**CITY OF PORTLAND, MAINE
DEVELOPMENT REVIEW APPLICATION
PLANNING DEPARTMENT PROCESSING FORM
DRC Copy**

44 Berry Street Ave
Project Name/Description

**CITY OF PORTLAND, MAINE
DEVELOPMENT REVIEW APPLICATION
PLANNING DEPARTMENT PROCESSING FORM
ADDENDUM**

MINOR SITE PLAN
AT 44 BERRY AVE PORTLAND, MAINE

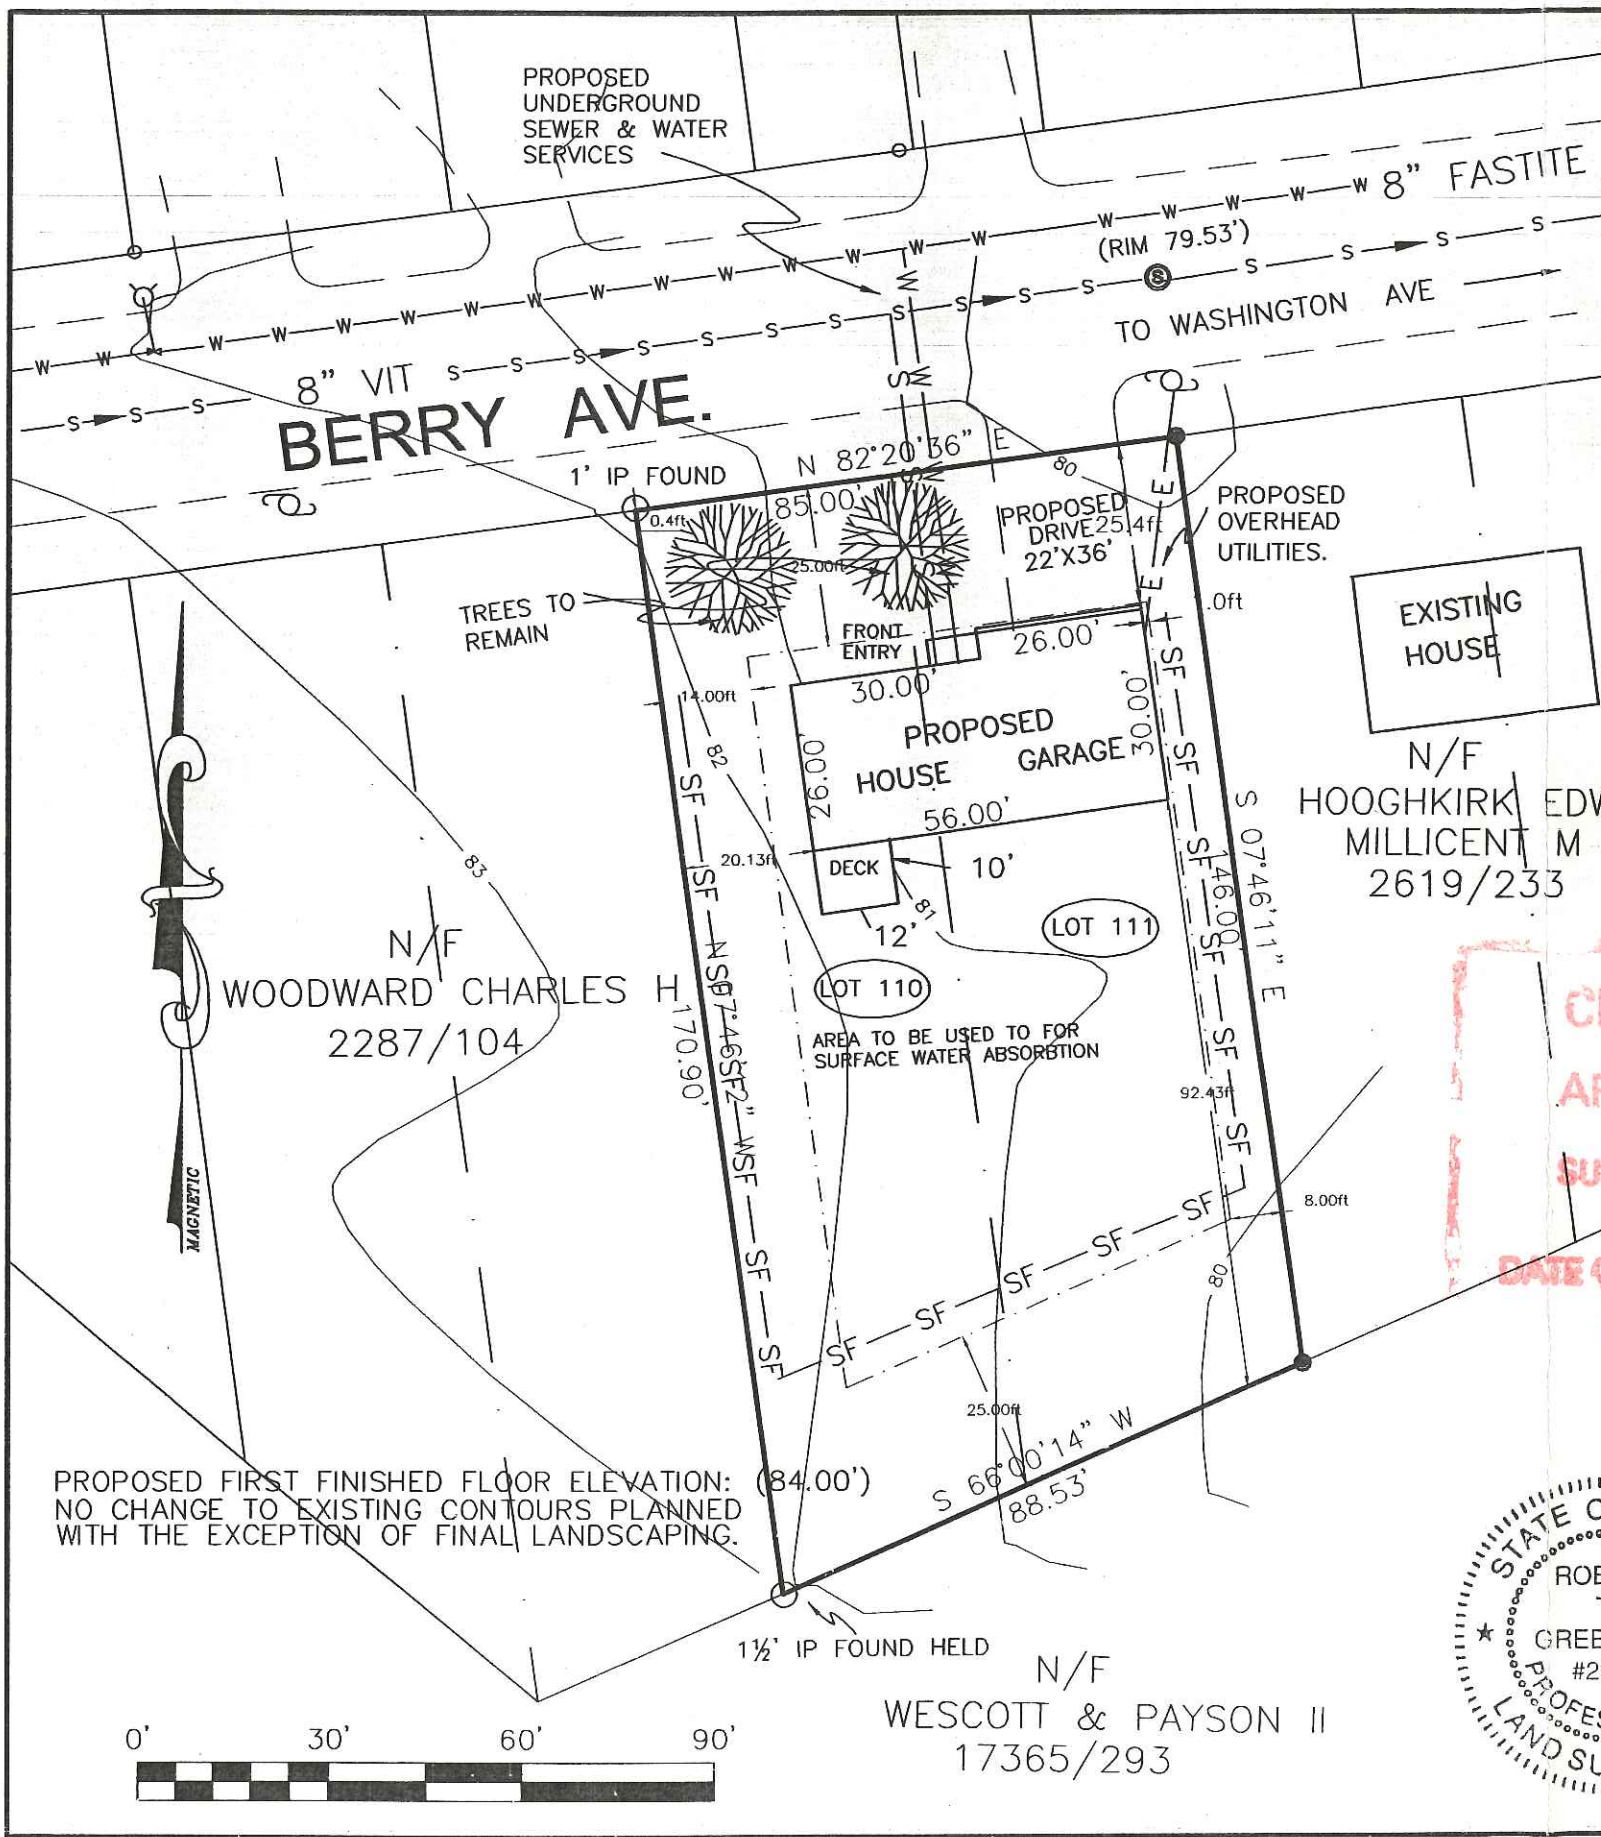
- 1 All damage to sidewalk, curb, street, or public utilities shall be repaired to City of Portland standards prior to issuance of a Certificate of Occupancy.

- 2 Two (2) City of Portland approved species and size trees must be planted on your street frontage prior to issuance of a Certificate of Occupancy.
- 3 Your new street address is now #44 BERRY AVENUE, the number must be displayed on the street frontage of your house prior to issuance of a Certificate of Occupancy.

- 5 A sewer permit is required for you project. Please contact Carol Merritt at 874-8300, ext . 8822. The Wastewater and Drainage section of Public Works must be notified five (5) working days prior to sewer connection to schedule an inspector for your site.

- 6 A street opening permit(s) is required for your site. Please contact Carol Merritt ay 874-8300, ext. 8822. (Only excavators licensed by the City of Portland are eligible.)

- 7 As-built record information for sewer and stormwater service connections must be submitted to Public Works Engineering Section (55 Portland Street) and approved prior to issuance of a Certificate of Occupancy.

- 8 The Development Review Coordinator reserves the right to require additional lot grading or other drainage improvements as necessary due to field conditions.

- 9 NO CHANGES IN GRADING IS PROPOSED. ANY CHANGES IN TOPOGRAPHY SHALL REQUIRE ADDITIONAL REVIEW AND APPROVAL BY THE CITY.

REAR ELEVATION
SCALE 1/4" = 1'-0"

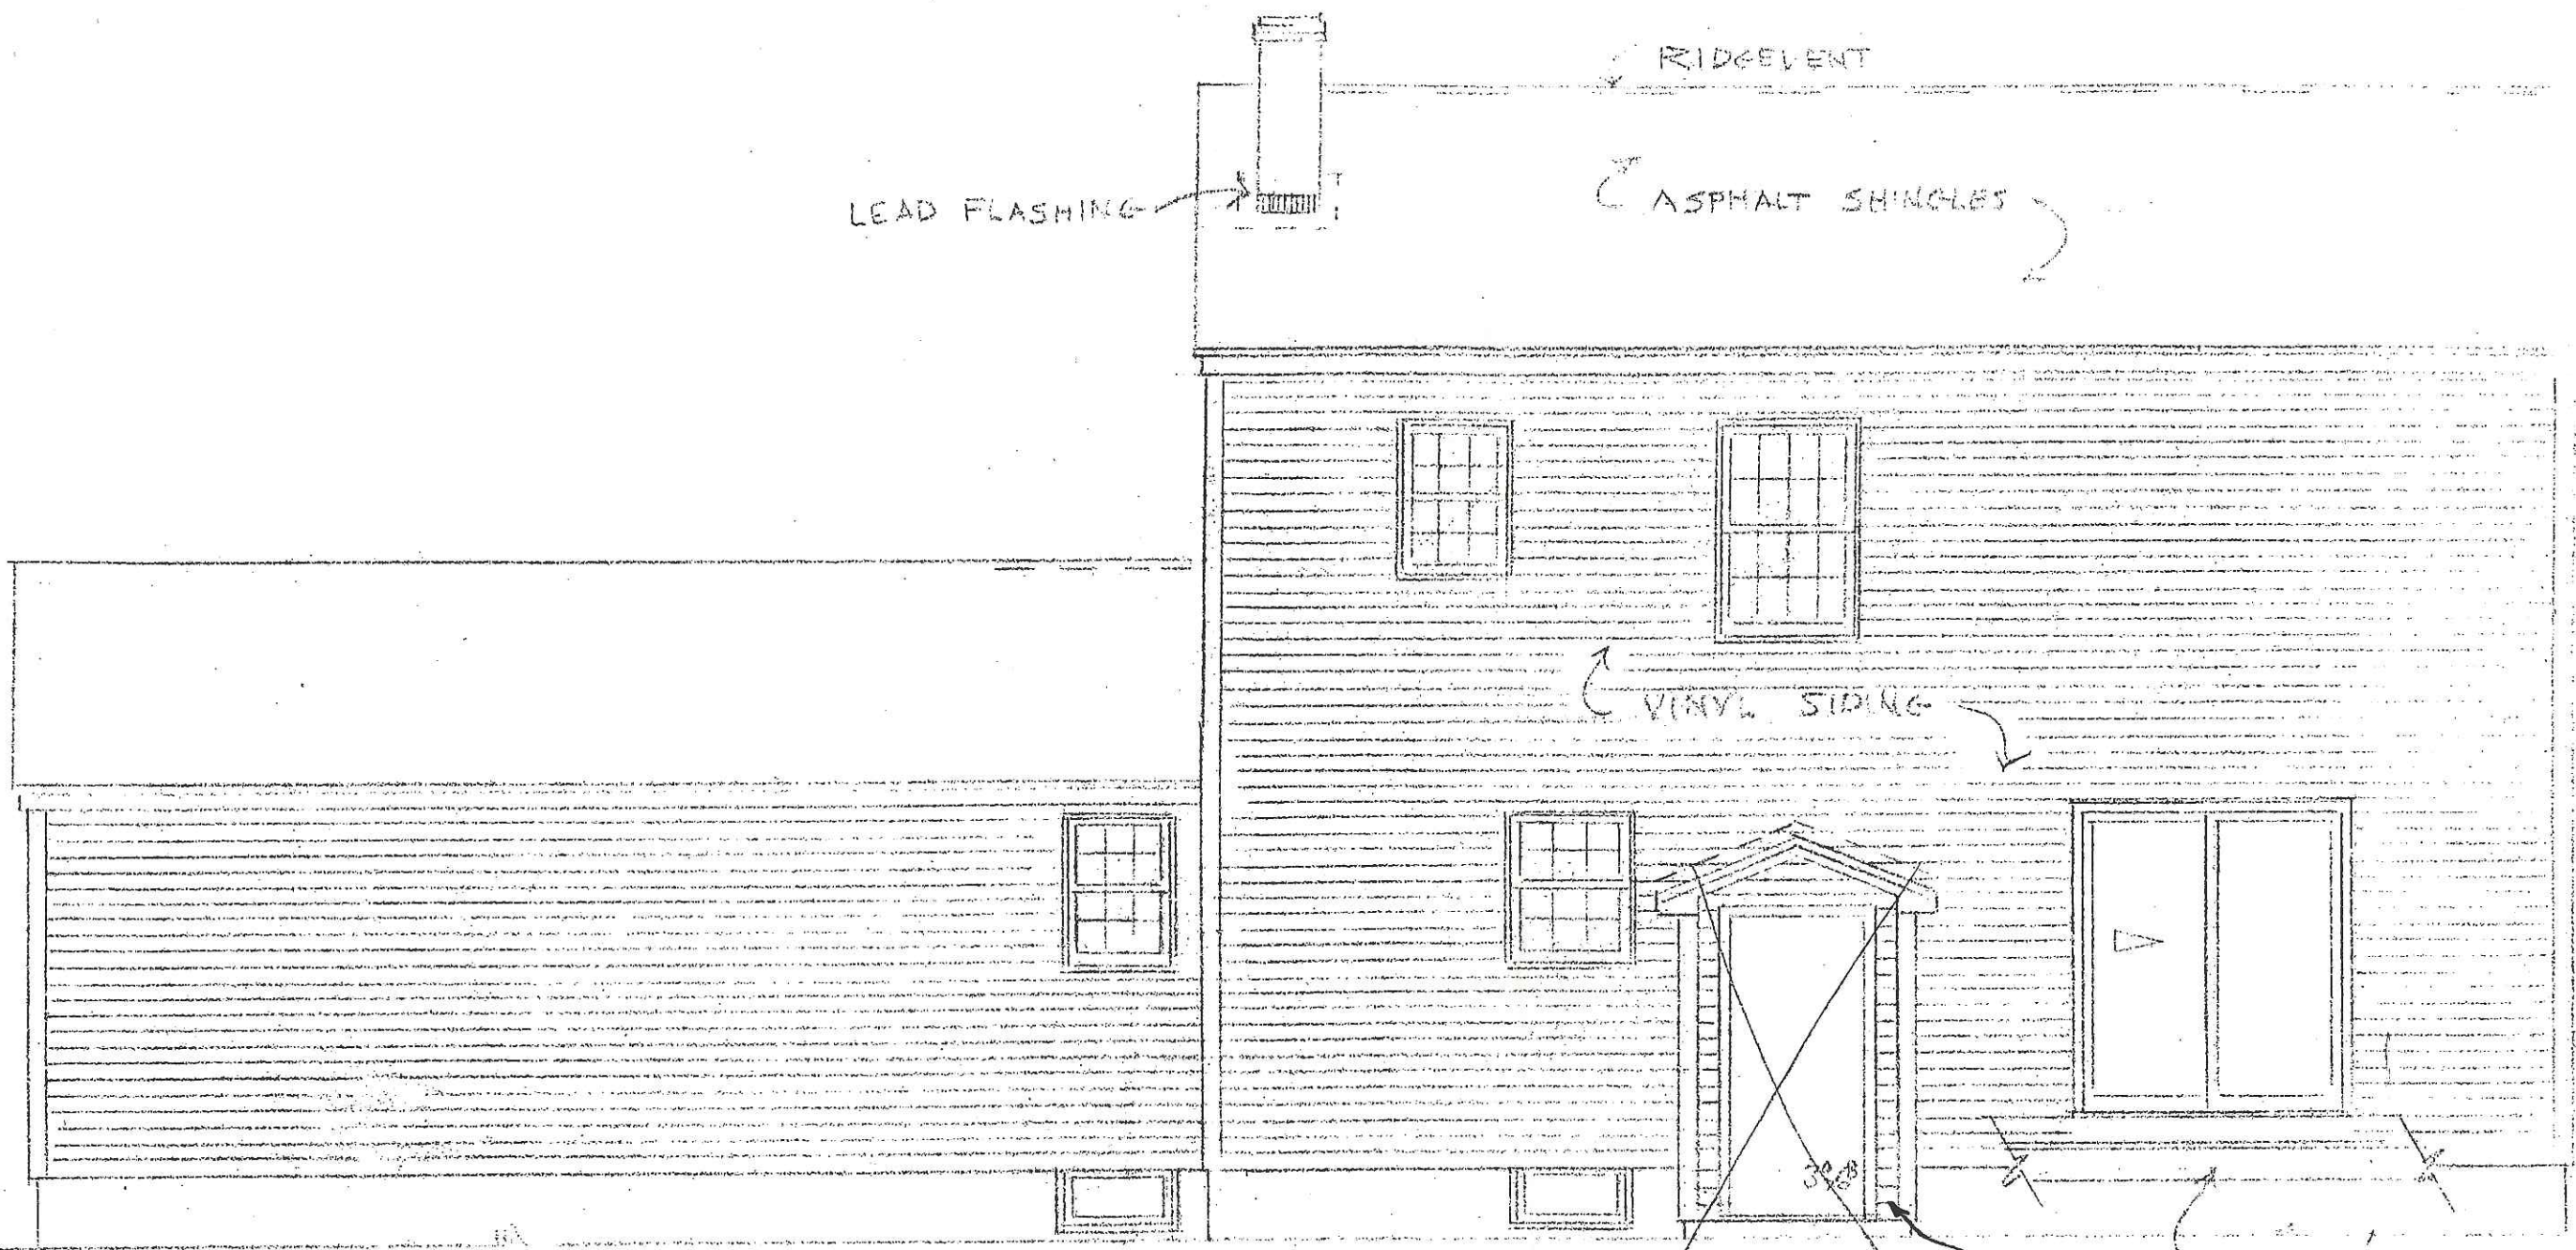
DELETE
DOG HOUSE

48'
 REVERSE PLAN

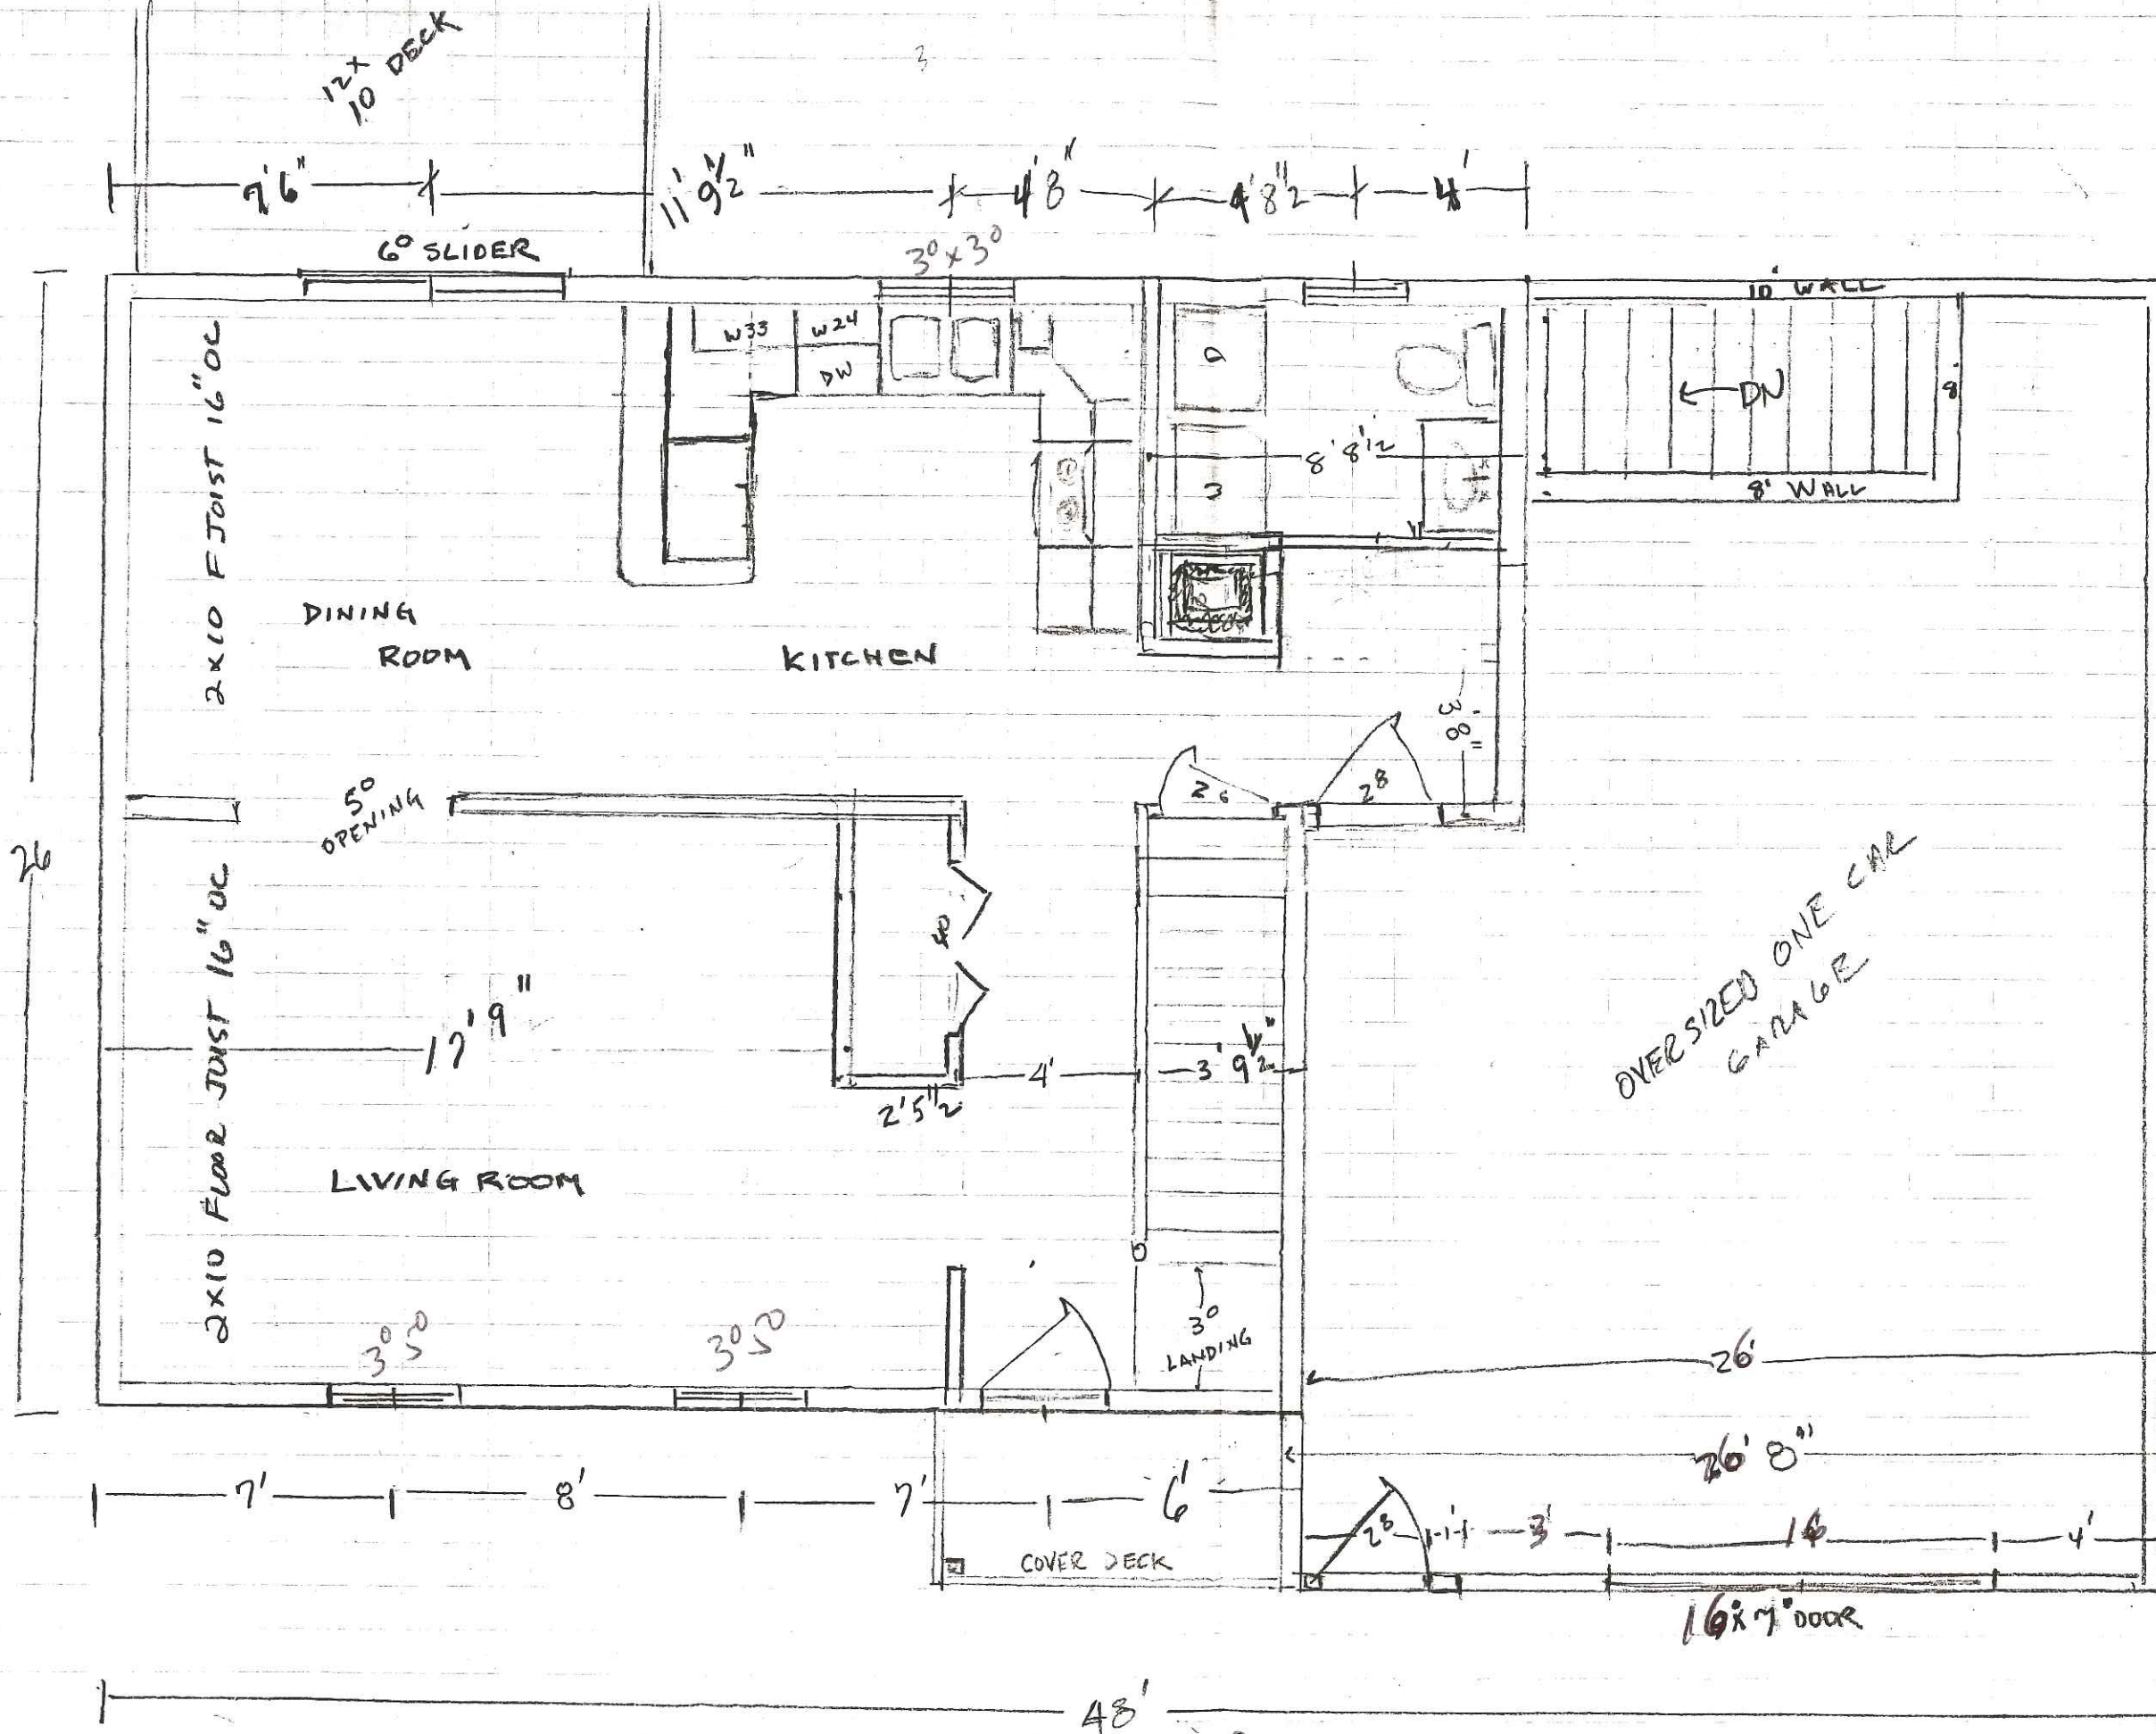
DROP TOP OF CLEAR ENTRANCE
FOUNDATION DOWN TO APPROX.
4" ABOVE FINISH LOAM GRADE
